Subject: RE: Planning Application 4/26/2224/0F1

Plan showing proposed
direction of travel

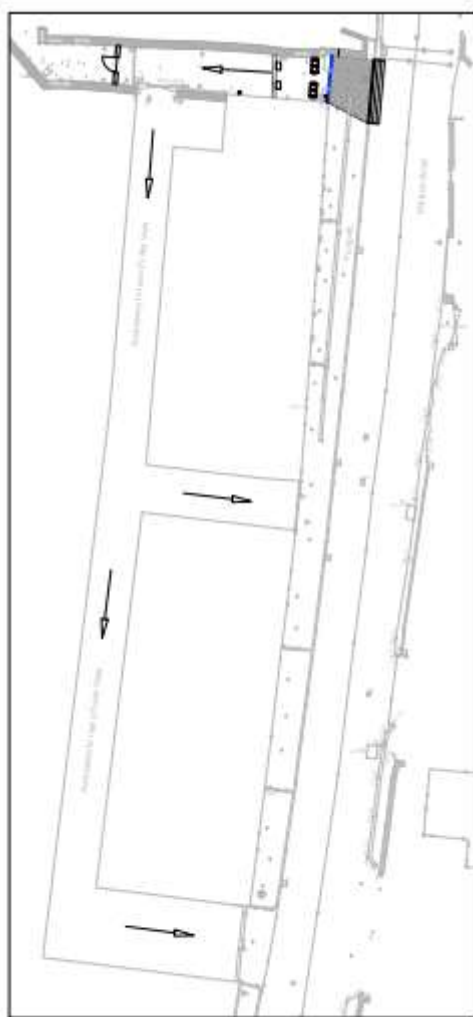
I have reviewed the design drawings again and am satisfied with our previous assessment and conclusion that 'one-way traffic flow plates will be installed to control vehicle movements, permitting inward access only. Vehicle egress will continue to be via the Lake View lane, as existing' Vehicle access plates make it impossible to drive over them the wrong direction, so no egress can be made at the entrance.
